Project Name:	Upper Culham Farm, Henley
Document Reference:	538.0015/DSMP/2
Document Name:	Delivery and Servicing Management Plan
Prepared By:	Luke Rodgers (September 2025)
Checked By:	Laura Jones (September 2025)
Approved By:	Izzie Drohan (September 2025)

- 1.1 This Delivery and Servicing Management Plan (DSMP) has been prepared by Paul Basham Associates to address highway comments (dated 15th August 2025) made by Wokingham Borough Council (WBC) in relation to a full planning application for equestrian uses at Upper Culham Farm, Henley.

From:	BA / JP		
Service	WBC Highways	App No:	251143
Address:	Upper Culham Farm, Upper Culham Lane, Remenham Hill, Wokingham, RG10 8NR.		
Proposal:	Full application for change of use of arable land to Equestrian use, construction of polo field, levelling of land for stick & ball and schooling fields, 3x American Barns, 2x horse walkers, exercise track, irrigation pond, pump house, sand turnout corrals, horse rehabilitation pool, conversion of existing barn into staff day facilities, construction of pavilion, construction of estate tracks, creation of new main access, creation of open storage yard and associated works.		
Type of Development:	Major

Title	ARTICULATED AND FIRE APPLIANCE VEHICLE SWEEP PATH ANALYSIS
-------	--

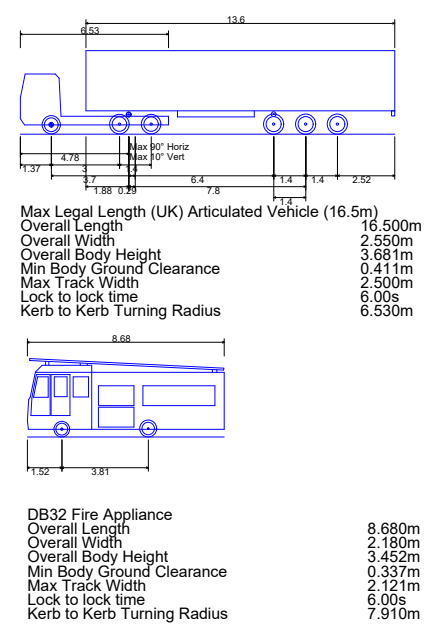
1. The LHA is concerned if the largest vehicles will be able manoeuvre at the proposed 90-degree bend circa 40m from the edge of the carriageway. The applicant is recommended to review the design.
2. The internal estate roads shall be no less than 6m wide to accommodate two-way traffic of heavy vehicles.
3. If site users are expected to walk between site facilities, a continuous 2m paved footway and suitable crossing facilities are required.
4. 90-degree bends shall be avoided whenever possible.

1. Details of all deliveries, servicing and refuse collection the site will need to be provided. This shall include but not be limited to the breakdown of vehicle types and frequency for all types of delivery and servicing. The applicant may wish to refer to the existing site of similar nature.
2. Swept path analysis of fire tender and refuse collection vehicle shall be submitted.
3. A framework Delivery and Servicing Plan will need to be submitted to ensure efficient delivery of goods, and access by service and emergency vehicles as required in Paragraph 117 of NPPF.

- 4.1 Despite the modest impact of the proposals as a result of the private operation, the proposed development will be served by an internal access road measuring 6.0m wide. Although considered to be a very infrequent occurrence, this is of sufficient width to allow a 16.5m articulated lorry and car to pass along the straight sections. Turning facilities have been provided onsite including sufficient space within the truck parking provided to the southeast of the site to accommodate a 16.5m articulated lorry as a worst case in addition to suitable turning space adjacent the American Barns to accommodate a fire tender and enable it to get within 45m of all parts of the building as per Building Regulations. Vehicle tracking of a fire tender and 16.5m articulated lorry is attached as **Appendix E**.
